PCN

Change of the pin length of high current choke B82747S4423N020

Product / Process Change Notification

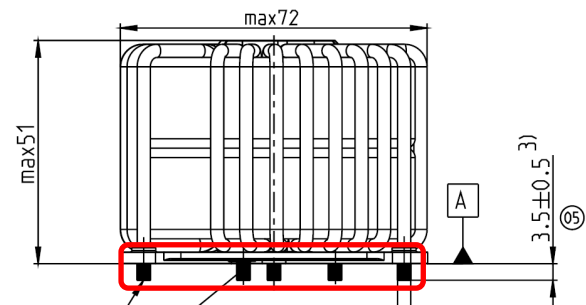
To standardize all pins with the catalog design, the pin length of the high current choke B82747S4423N020 will be changed from two different lengths (3 mm and 5 mm) to a single one ($3.5 \text{ mm} \pm 0.5 \text{ mm}$).

Previous:

New:
